2014 - 2016 Corvette: Service Bulletin: #16-NA-170: Brake Pulsation and/or Vibration During Brake Apply

#16-NA-170: Brake Pulsation and/or Vibration During Brake Apply - (July 20, 2016)

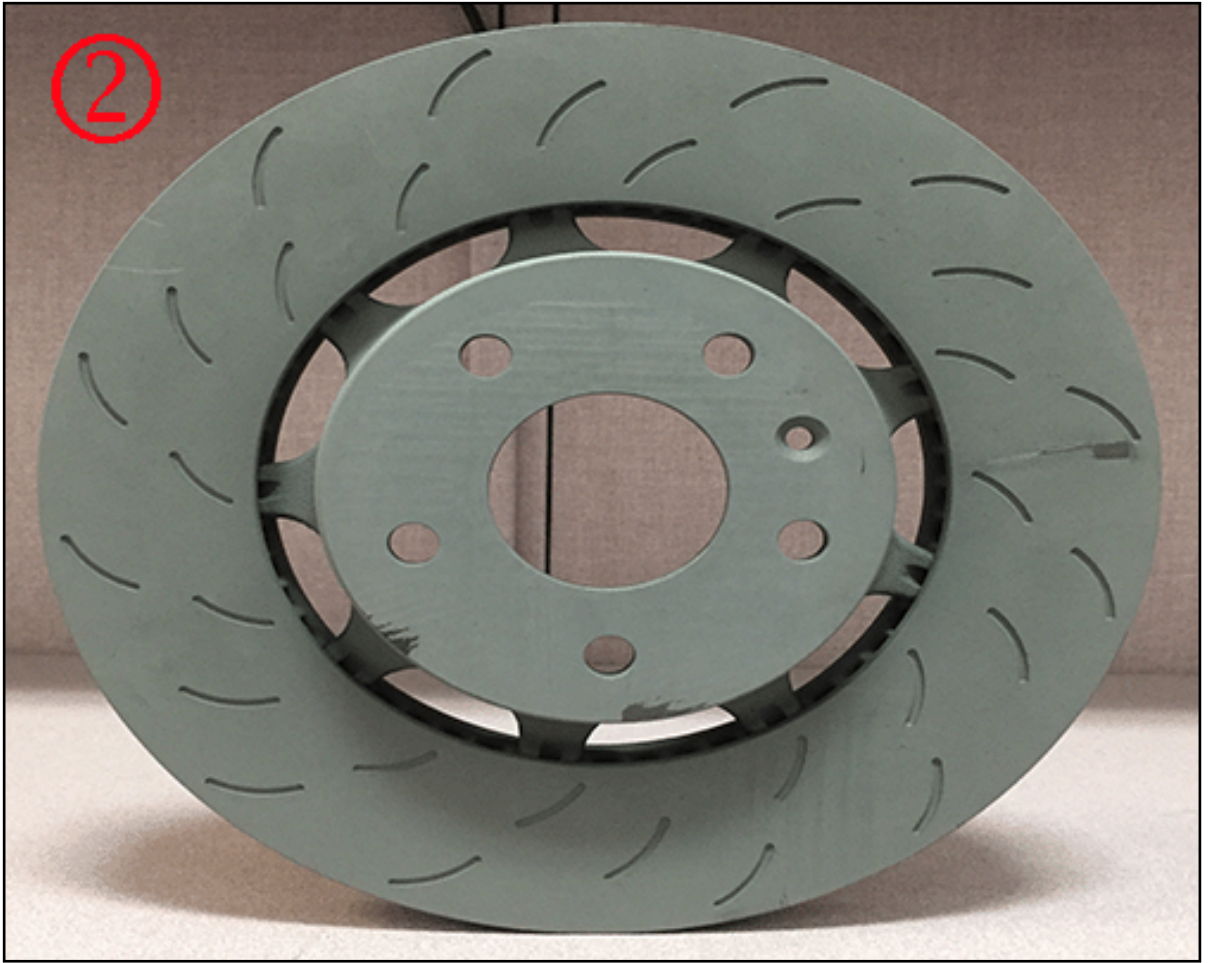
Customer may also comment they hear a rattle noise from the wheel area. The noise may go away when the brakes are lightly applied. This condition may be due to excessive lateral runout (LRO) or interation between the inner top hat section to the rotor ring.

- For front rotors and vehicles built prior to May 31, 2016, replace old two piece design (2) with new one piece design (1).
- For rear rotors and vehicles built prior to July 23, 2015, replace old two piece design (2) with new one piece design (1).

Important: The rotors *MUST* be replaced as a pair due to a design change.
